Airworthiness Directives; Cessna Aircraft Company 150 and A150 Series and Models 152 and A152 Airplanes

ACTION: Notice of proposed rulemaking (NPRM).

Cessna Aircraft Corporation: Docket No. 95-CE-14-AD.

FIGURE 1
MID-AMERICA DWG No. 1001
(STC SA1371 SW)

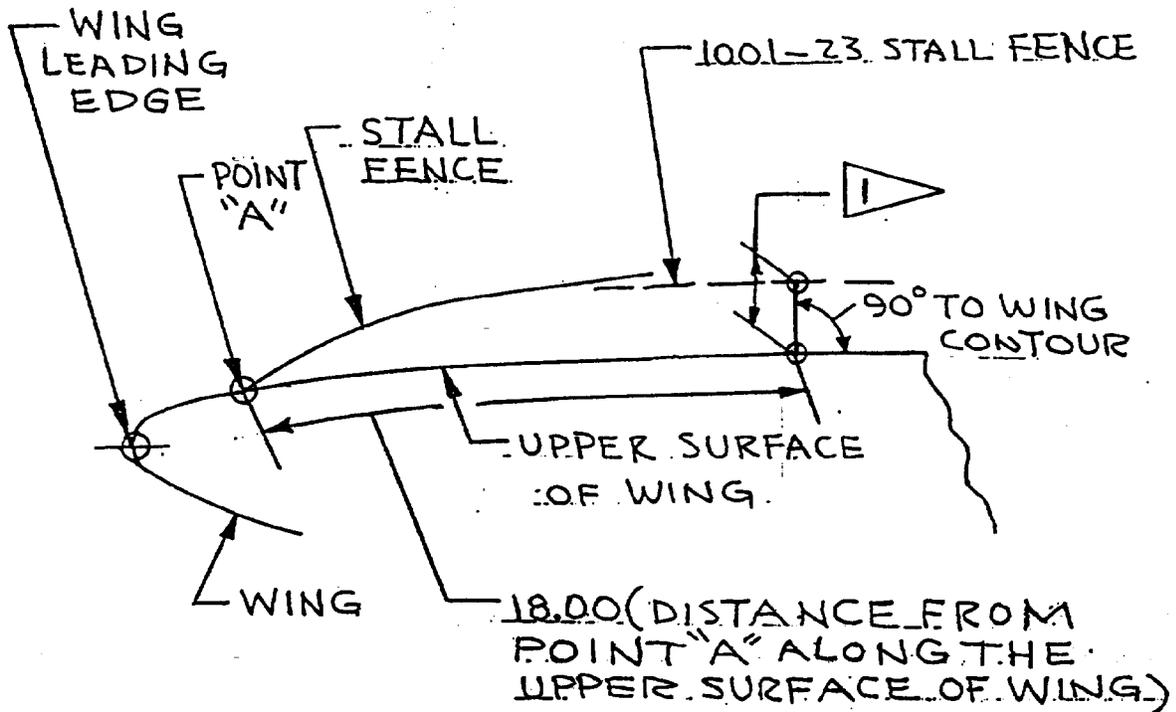
installed in accordance with Supplemental Type Certificate (STC) SA1371SW. This kit includes a wing leading edge cuff and stall fence on each wing that is installed on the top of the wing chordwise in line with the aileron/flap juncture. The wing stall fence on this Cessna Model 152 airplane measured 1.625 inches in height at its trailing edge and maintained that height through approximately 70 percent of the fence's length, gradually tapering to the contour of the wing's leading edge.

The FAA approved the fence height of the Bush Conversions, Inc., STOL kit at a height of 1.16 inches (plus or minus .12 inches) for Cessna 150 and A150 series and Models 152 and A152 airplanes. Mid-America Drawing No. 1001 references this height and is included as part of STC SA1371SW. Mid-America Drawing No. 1001 is included as Figure 1 of the proposed AD.

Since the referenced accident, the National Transportation Safety Board (NTSB) and the FAA inspected three other Cessna 150 series airplanes and found the STOL kit fence heights ranging from 1.375 inches to 1.75 inches.

1 ▽ IF STALL FENCE IS $1.16 \pm .12$ HIGH, THAT IS CORRECT HEIGHT FOR STALL FENCE. IF GREATER THAN 1.28 HIGH, REMOVE STALL FENCES AND INSTALL THE CORRECT ONE.

(a) Measure the height of the wing stall fence at its trailing edge to ensure that the height does not exceed 1.28 inches. (See Figure 1 of this AD).

(b) If the wing stall fence height exceeds 1.28 inches, prior to further flight, install a smaller fence in accordance with instructions obtained from the Wichita Aircraft Certification Office (ACO), FAA, 1801 Airport Road, Mid-Continent Airport, Wichita, Kansas 67209.
